## City of Yarra Planning Application DAP Report

<b>Application No:</b>	PLN18/0328
<b>Land Address:</b>	459-471 Church Street & 20 – 26 Brighton Street, Richmond
<b>Current Land Use:</b>	Furniture Showrooms, car park and dwelling
<b>Zone/s:</b>	Part Commercial 2 Zone, Part General Residential Zone (Schedule 2)
<b>Overlay/s:</b>	Design and Development Overlay (Schedules 2 and 5) and CityLink Project Overlay (CLPO)
<b>Date Received:</b>	11 May 2018
<b>The Proposal:</b>	Use and development of the land for the construction of three buildings (ranging between four and fourteen storeys in height with two basement levels) for offices, restricted retail premises, food and drinks premises (cafe) and a child care centre (permit required for childcare centre only), reduction in car parking requirement, and alteration of access and building and works to a Road Zone Category 1 Road.
<b>Objections/Submissions:</b>	225 Objectors  18 Statements of Grounds
<b>Planning Officer:</b>	Vicky Grillakis

The purpose of this report is to form Council's position on the application.

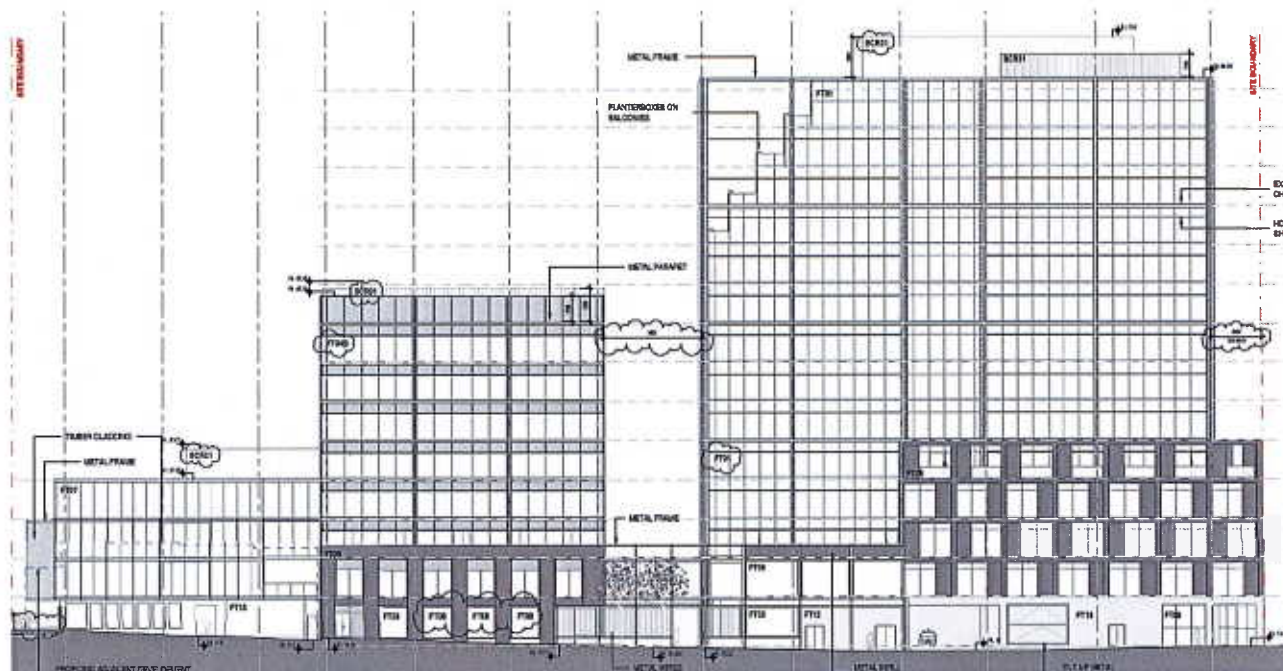
Council's external urban designer suggested that the lift core should be internalised to avoid the southern boundary wall, however planning officer's believe there may be other solutions which would also resolve this issue. Again, this is a failing of the proposal which cannot be resolved by way of a condition on permit, but would need the applicant to provide a re-design for further consideration.

In terms of architectural quality, the tower of Building A will be constructed of metal cladding, concrete and glazing which is quite typical of office developments. Along the western façade the tower is horizontally separated into three groupings of three levels each with increasing visual transparency from the lower levels to the upper levels. These bands are also vertically separated. Along the northern boundary, the horizontal bands of each level are visible, as is the central indentation. This all assists in creating a visually interesting and articulated building, however as already stated, the external framing element, the southern boundary and the overall height result in the dominating impact of the building which is unacceptable.

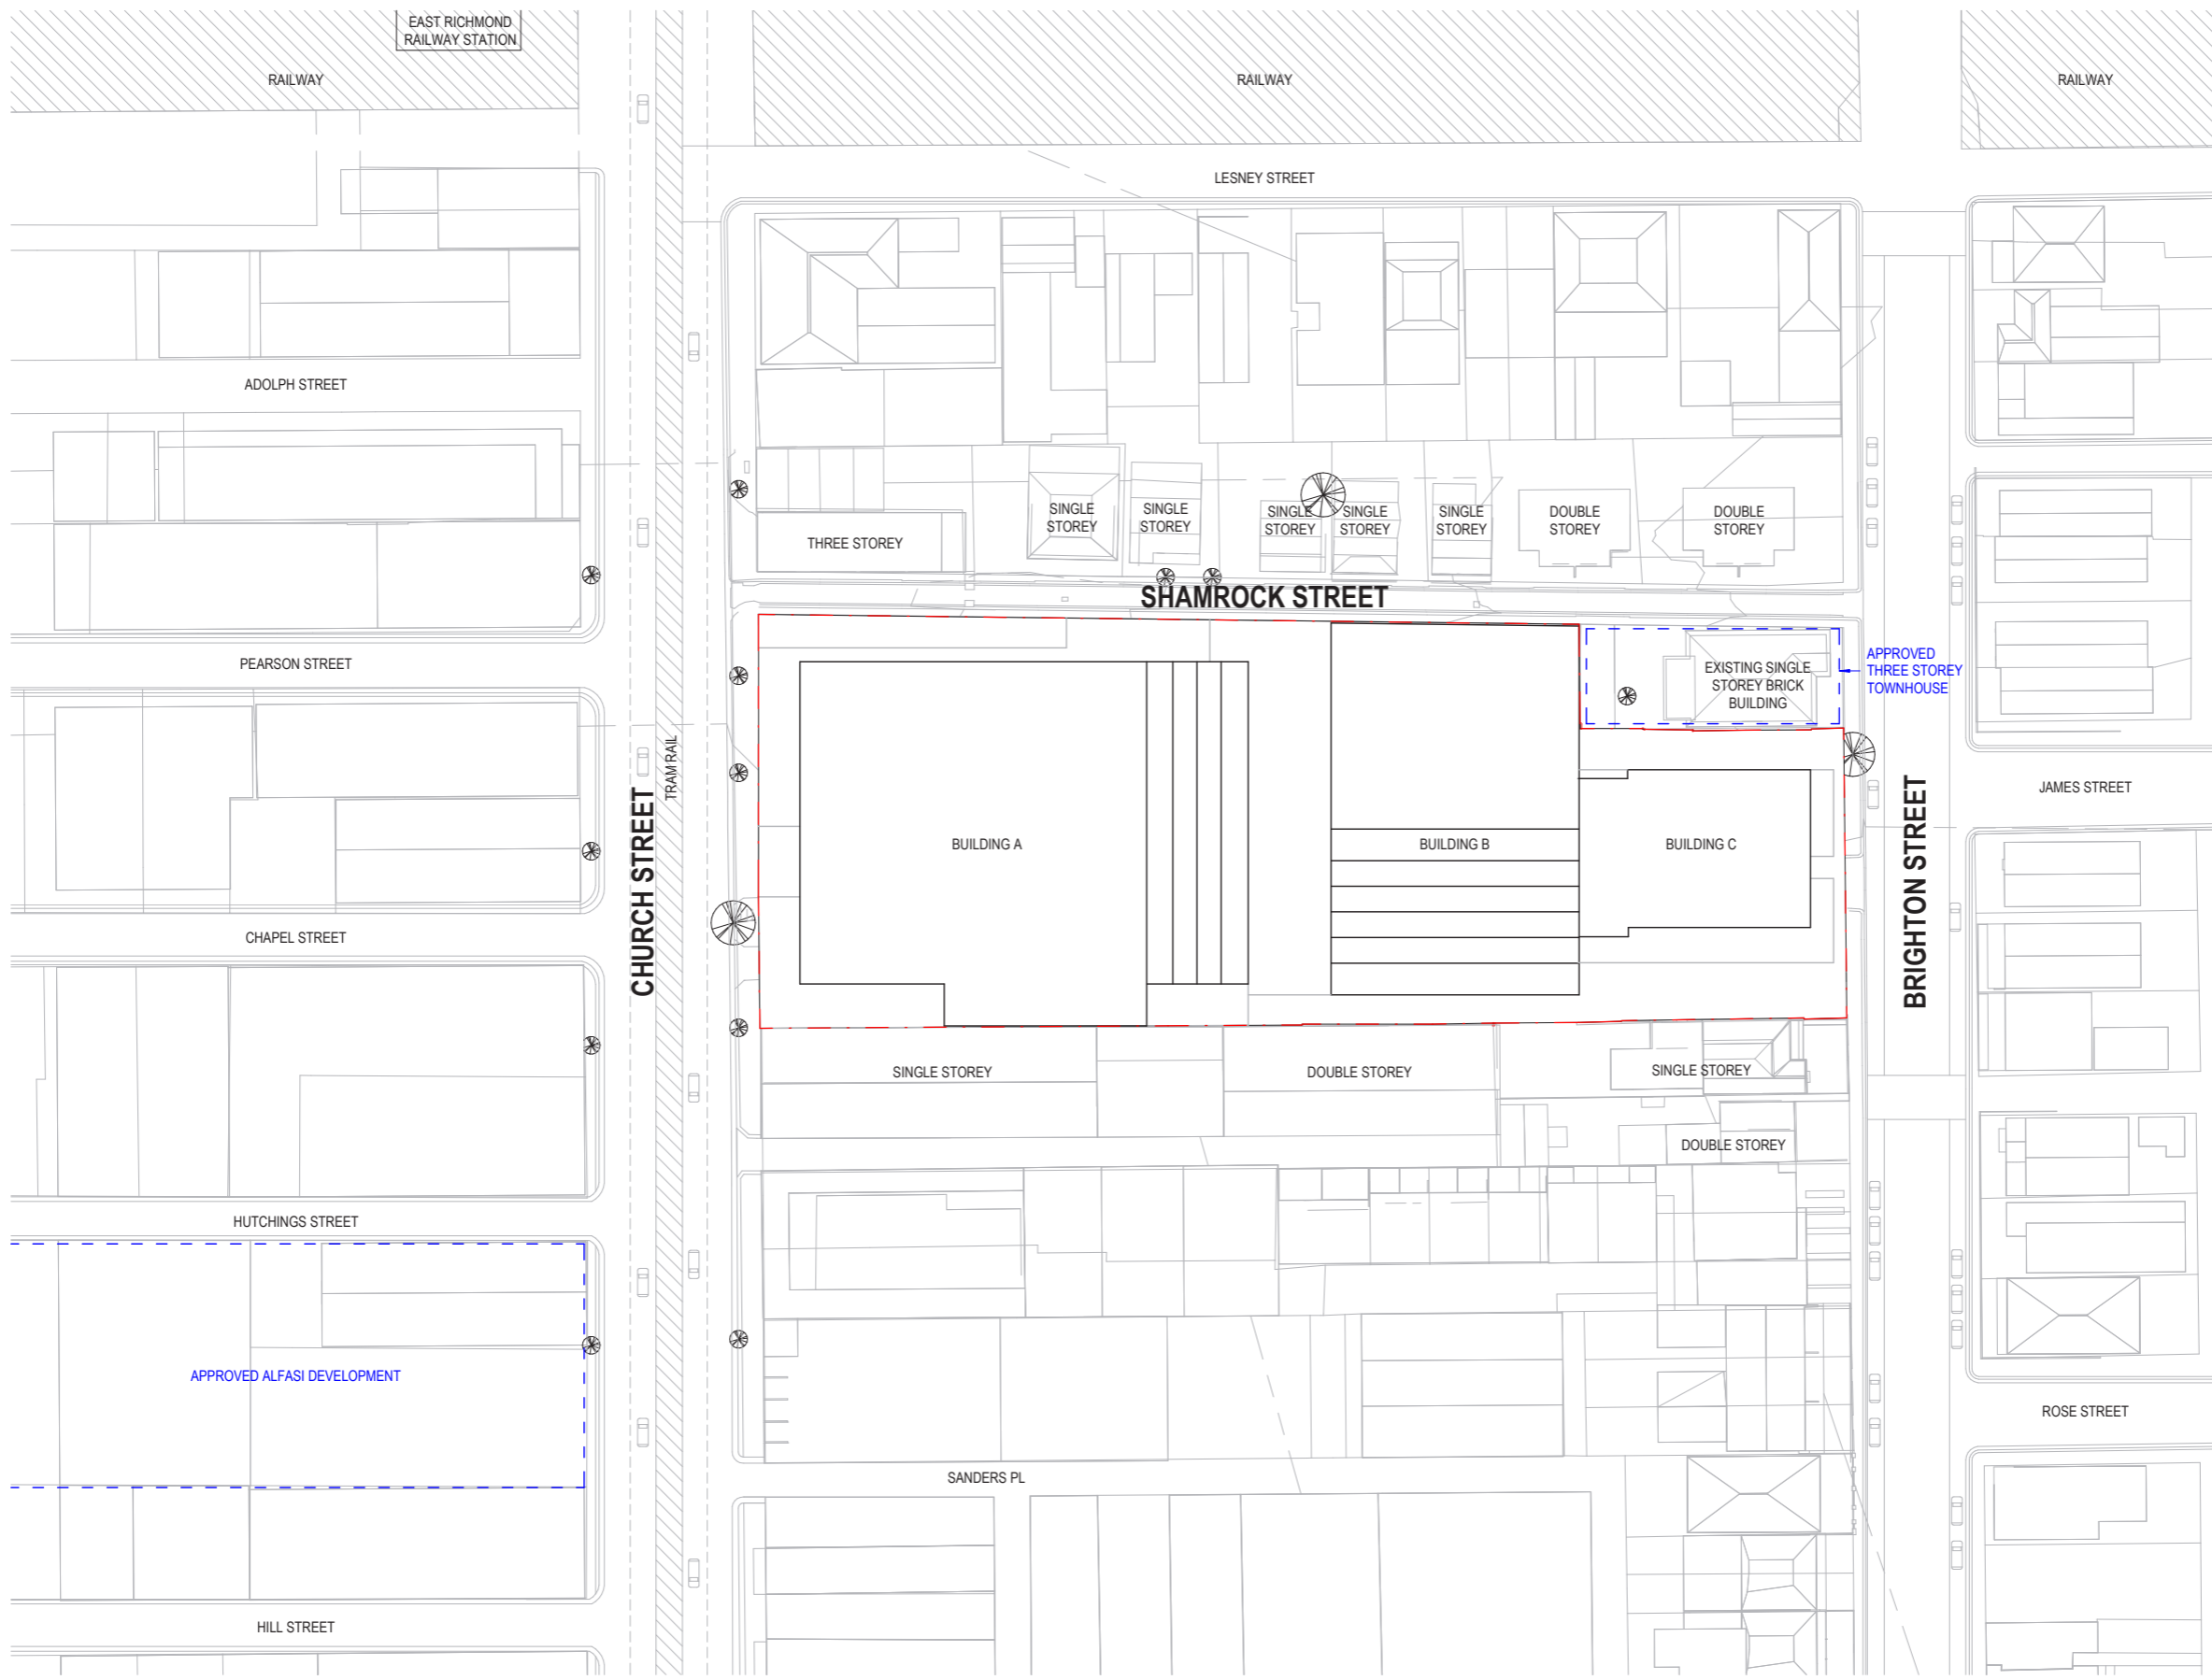
*In relation to the adjoining mid-block office building, it was my view that this building was grossly excessive in scale relative to its adjoining Heritage Overlay and neighbourhood context within Shamrock Street to the north and the private open space of residential areas that exist to the south. To this extent I recommended removal of levels above the fourth floor to these interfaces i.e. that levels 5 to 7 are deleted. I am of the view that the revised scale is appropriate.*

*In relation to the western tower, I didn't find it acceptable that the lift core was built to the southern boundary to the full height as is currently proposed nor that it relied on glazed aspect to its southern boundary for amenity to this zone. I recommended that The lift core should be embedded into the development, not incorporated into a boundary interface as suggested in this instance I am satisfied that the revised approach is acceptable subject to mitigating overshadowing noted earlier.*

*The scale of development also needs to be addressed so that the western side of Church Street is not impacted in the early morning peak pedestrian movement times from public transport to the adjoining workplace areas and similarly reduced so that the private open space of adjoining residential areas to the south east are not impacted at peak times of the day. I would suggest in this instance between 10.00am and 2.00pm at the equinox as noted earlier.*

*The proposal in this instance needs to be radically reduced in scale. My view is that whilst I am satisfied that the proposed podium is acceptable, it is my view that development above level 7 should be deleted, having regard for the substantive plant area above this zone. This would result in a building including plant of approximately RL42.5 in height or effectively 32m in height relative to street level. I note the applicant has returned with a proposal for approximately 41m excluding plant to the top of parapet level, Effectively a 9 level commercial building. Subject to increased setbacks to manage offsite overshadowing I am of the view on a site of this size this may be able to be effectively managed but would like to review the revised footprint and elevations with the recommended inclusions.*
